Landscape Referral Response

Application Number:	REV2021/0035
Date:	08/10/2021
Responsible Officer:	Julie Edwards
Land to be developed (Address):	Lot 82 DP 10782 , 114 Whale Beach Road WHALE BEACH NSW 2107

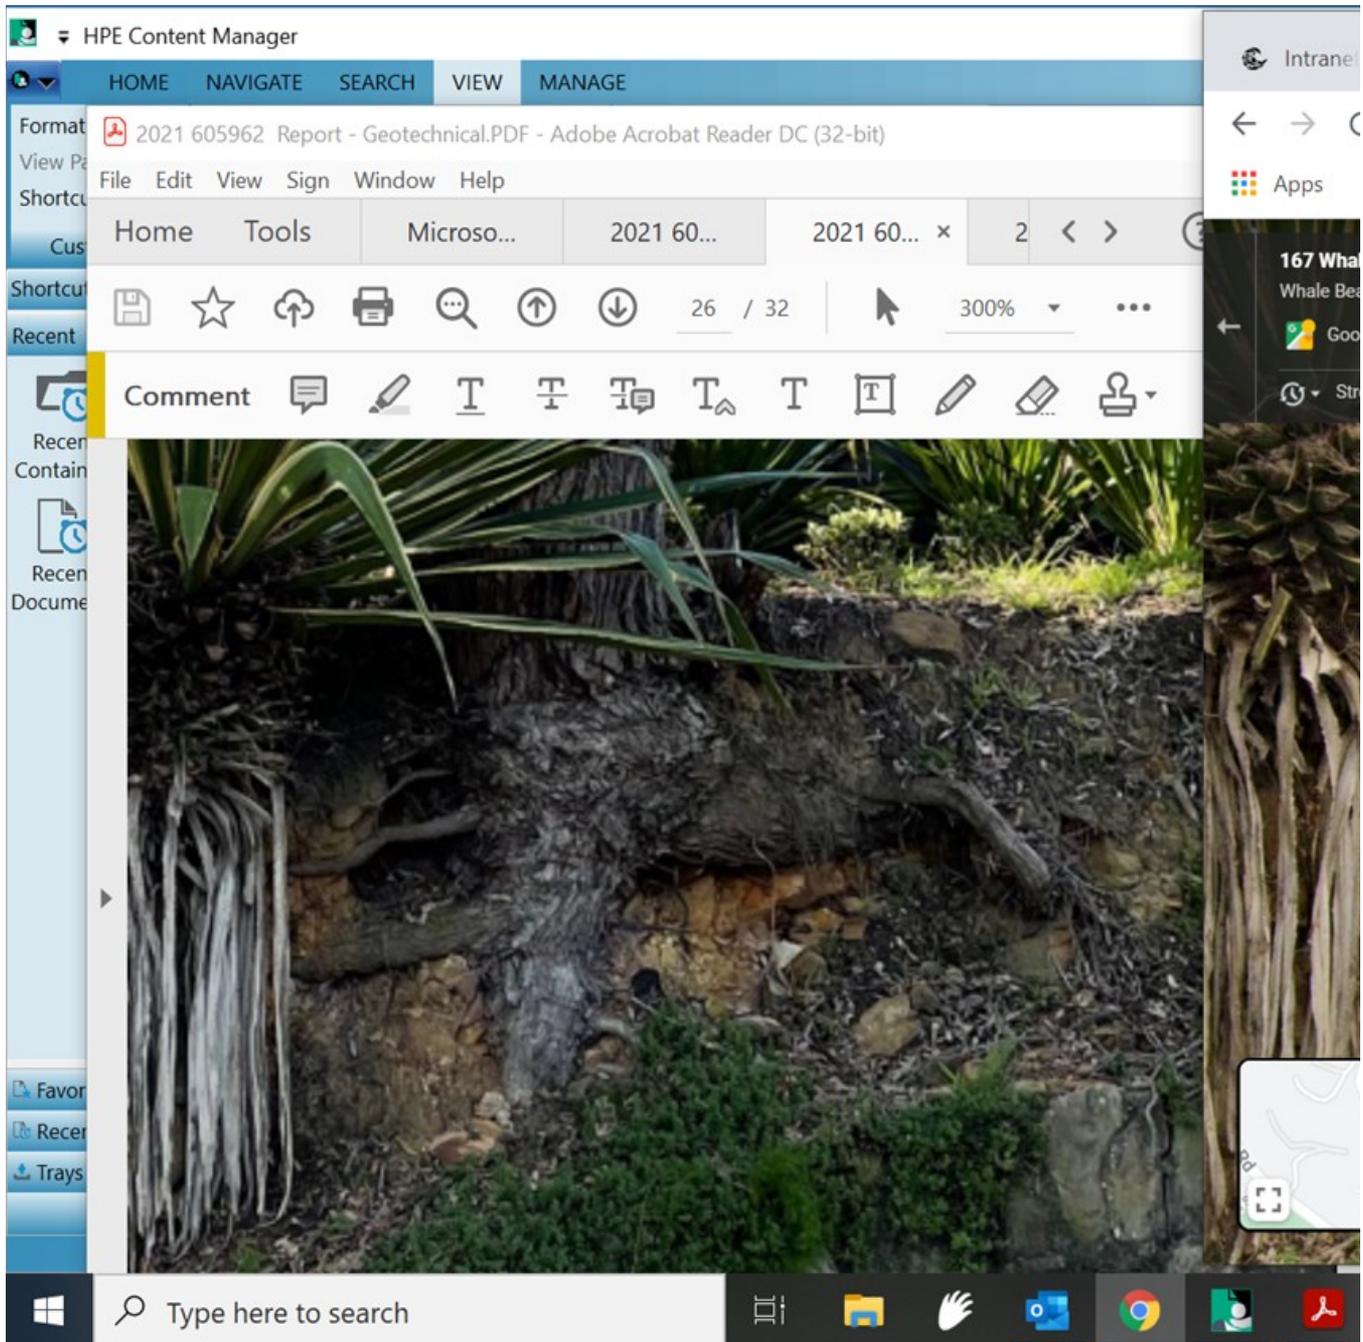
The tree has been located on top of the embankment and though some structural roots are exposed, it appears to have been in this condition for some time and appears stable at present.

Below is a comparison of the exposed roots as currently exists on the left side photo (Source: Geotechnical Report dated 1 April 2021 prepared by AssetGeoEnviro) with street view image from

2018. (Source Google Maps, 2018).

As the removal of the tree is ultimately required to provide a functional and safe driveway for the affected properties and as there is no alternative to this outcome, in this instance no objections are

raised to removal subject to replacement and planting as indicated on the landscape plans provided.
